Urban Design Commission Revised S.I.P. Resubmission - Letter of Intent
DUPLEX HOUSING
8549 & 8557 Elderberry Road
Madison, Wisconsin
Dimension IV Project No. 19014
September 11, 2019

Reference: 8549 & 8557 Elderberry Duplex Housing
Final Approval Submission

ELDERBERRY DUPLEXES - 8549 & 8557 ELDERBERRY ROAD

REVISED S.I.P. SUBMITTAL - URBAN DESIGN FINAL APPROVAL

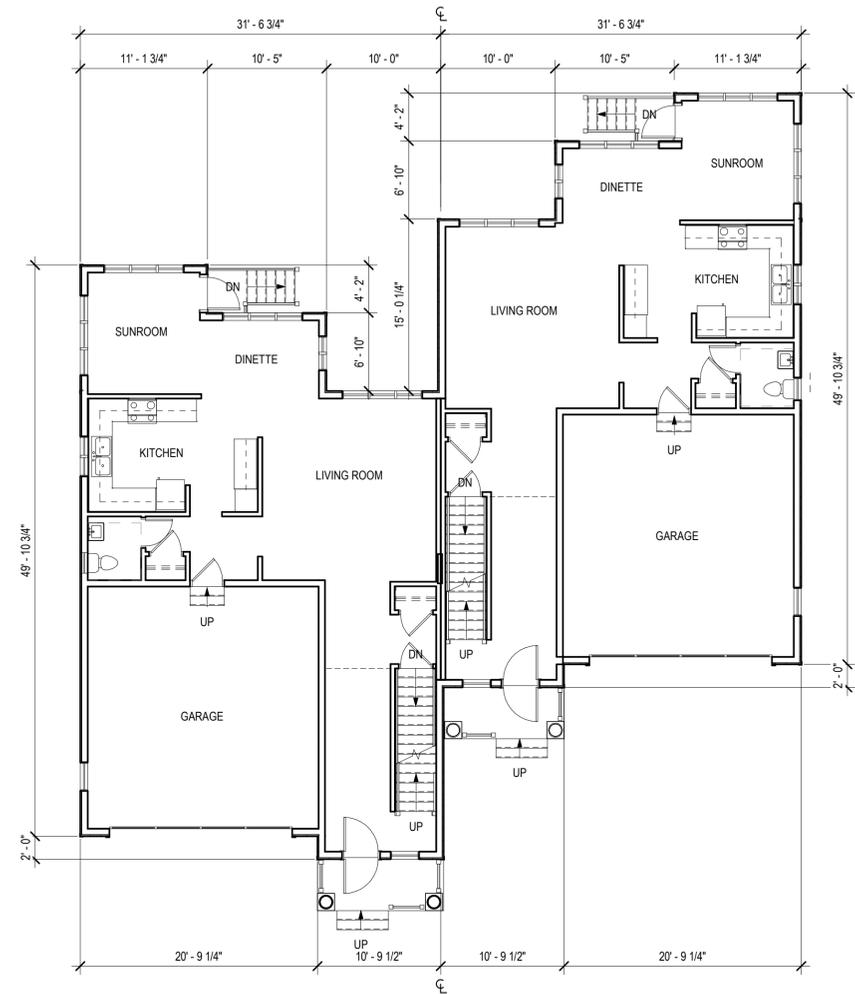
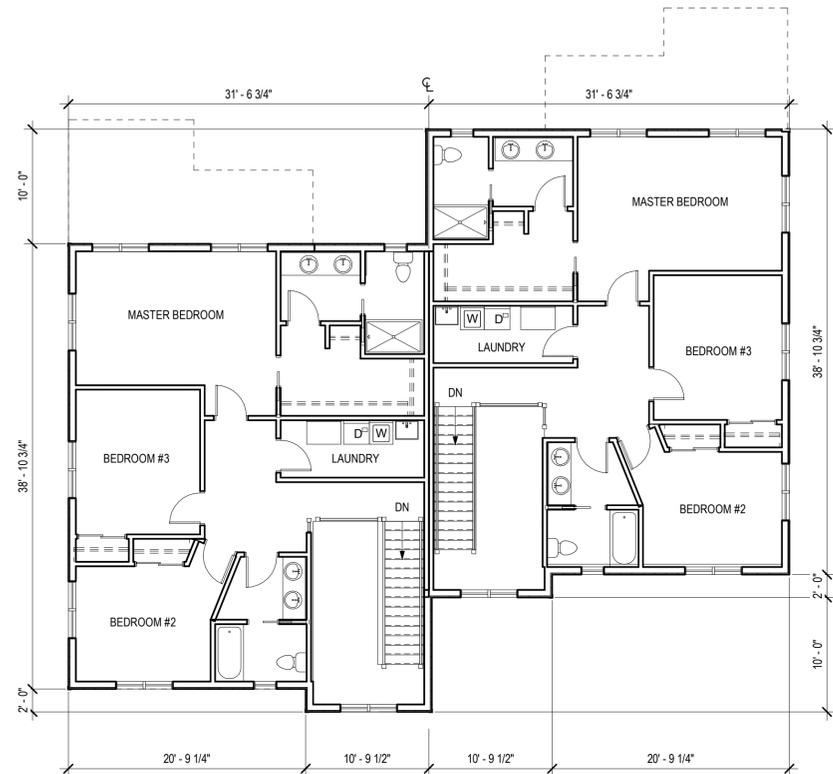
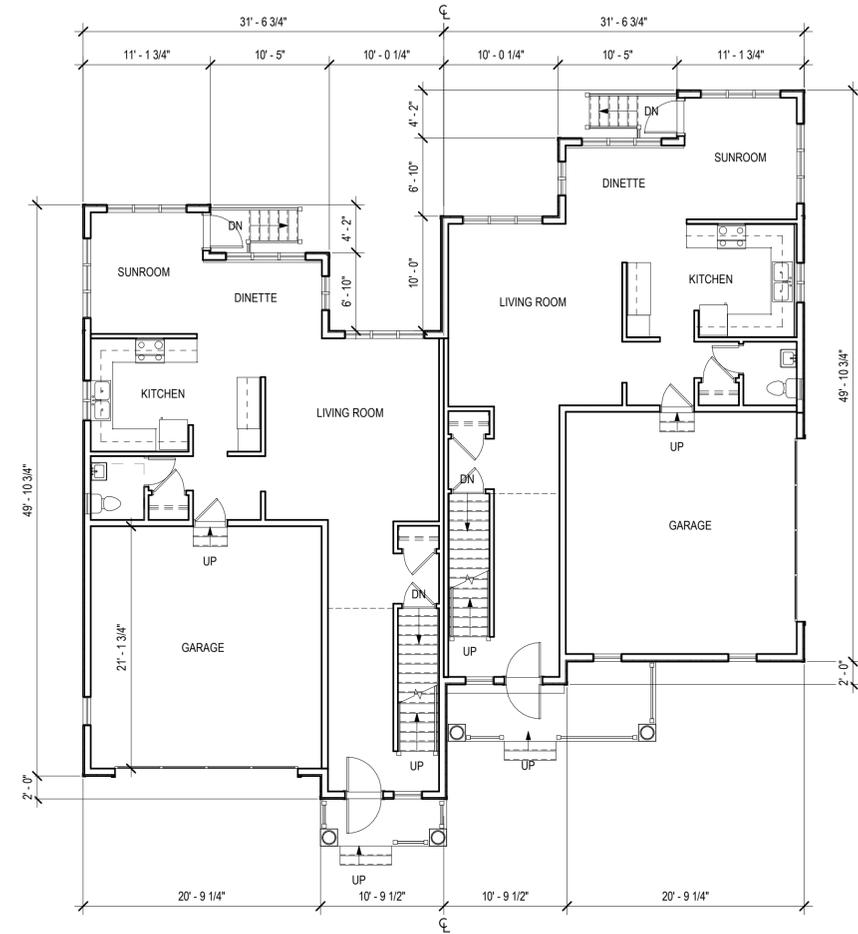
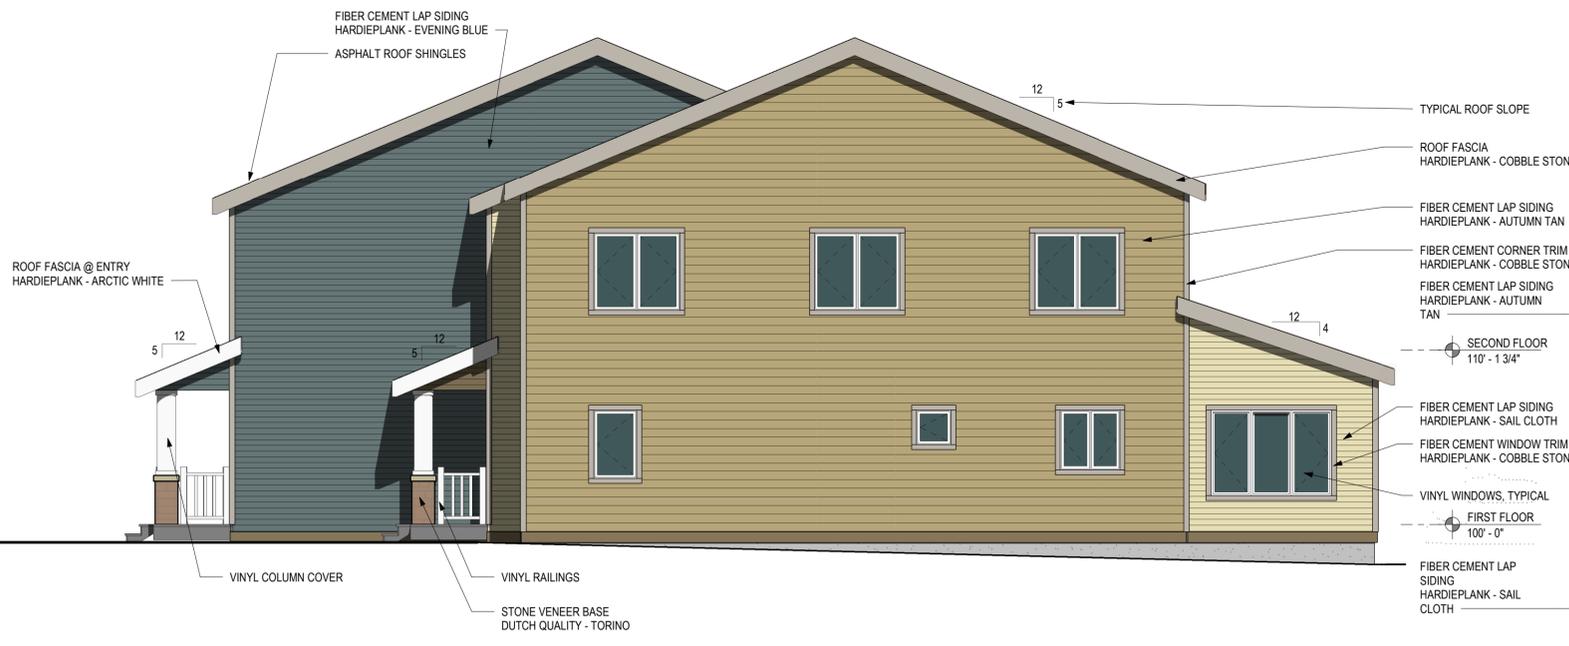
1. The building floor plans were revised to locate the bedrooms at the outside corner of the floor plan. The closets and bathrooms were pulled into the interior areas.
2. The jogs in the floor plan were reduced to simplify the exterior walls.
3. Windows were added in the bathrooms and bedrooms. Blank wall areas were reduced.
4. The roof lines were simplified to reduce the amount of gables. Shed roofs were incorporated into the roof.
5. Window heads were aligned to develop a more unified appearance.
6. The building exterior materials and color pallets were simplified to have fewer colors and materials.
7. The white roof edge has been revised to blend in with the adjacent roof colors.
8. The landscape plan has been revised to eliminate the Burning Bush and Gold Flame Spirea. More substantial shade trees were added in the back.
